HISTORIC AND DESIGN REVIEW COMMISSION August 16, 2017

HDRC CASE NO: 2017-407

ADDRESS: 305 LAMAR ST

TYPE OF WORK: Construction of a rear addition

NEW SIDE ELEVATION

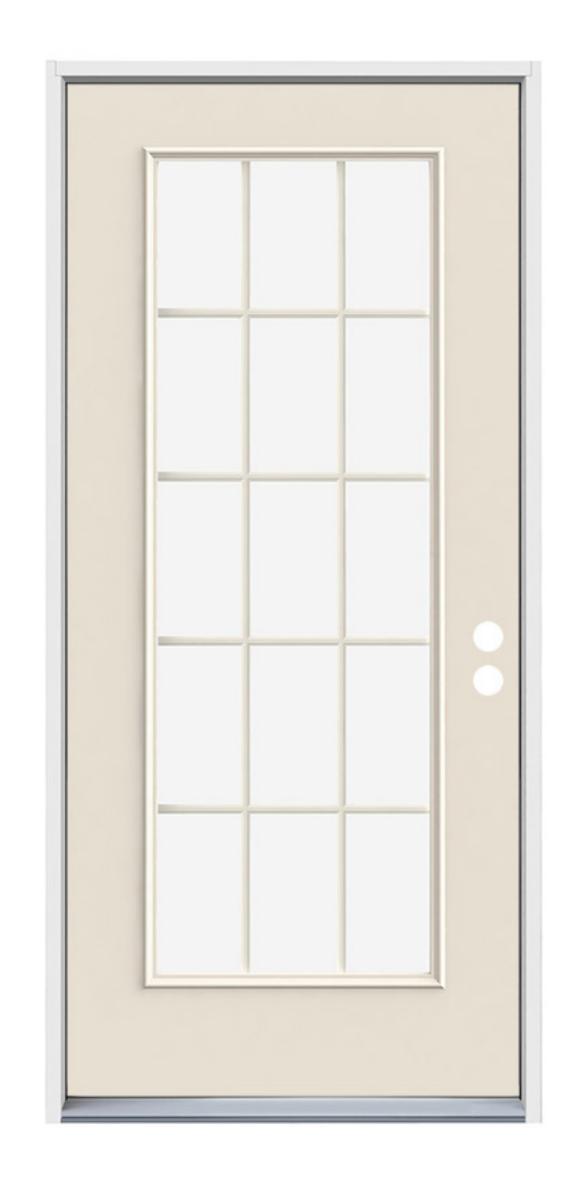
- d. MATERIALS The applicant has noted materials that are to include wood siding, an overhead rolling glass door, fixed windows and an asphalt shingle roof to match that of the historic structure. Staff finds that staff finds that one-over-one wood windows or aluminum-clad wood windows should be used and that the proposed wood siding should match that of the primary historic structure. Staff does not find the proposed overhead rolling door appropriate.

- e. TRANSITION As noted in finding b, the applicant has proposed a transition on the west side of the rear addition; however, that addition should also feature a transition on the east side of the addition that insets it from the wall plane of the primary historic structure.

- f. ARCHITECTURAL DETAILS While the proposed location and overall scale of the addition is appropriate, staff finds that a similar roof form as well as similar window and door openings should be incorporated into the addition to ensure that architectural details are consistent with the Guidelines for Additions.

- i. That the applicant install a hipped or gabled roof to relate to those of the primary historic structure as noted in finding f.
- ii. That the applicant install a double-hung, one-over-one wood windows or aluminum-clad wood windows be used based on finding d. Meeting rails must be no taller than 1.25" and stiles no wider than 2.25". White manufacturer's color is not allowed, and color selection must be presented to staff. There should be a minimum of two inches in depth between the front face of the window trim and the front face of the top window sash. This must be accomplished by recessing the window sufficiently within the opening or with the installation of additional window trim to add thickness. Window trim must feature traditional dimensions and architecturally appropriate sill detail (need to add detail here). Window track components must be painted to match the window trim or concealed by a wood window screen set within the opening.

- iii. That the applicant install an inset on the east façade to differentiate the addition from the primary historic structure as noted in finding e.
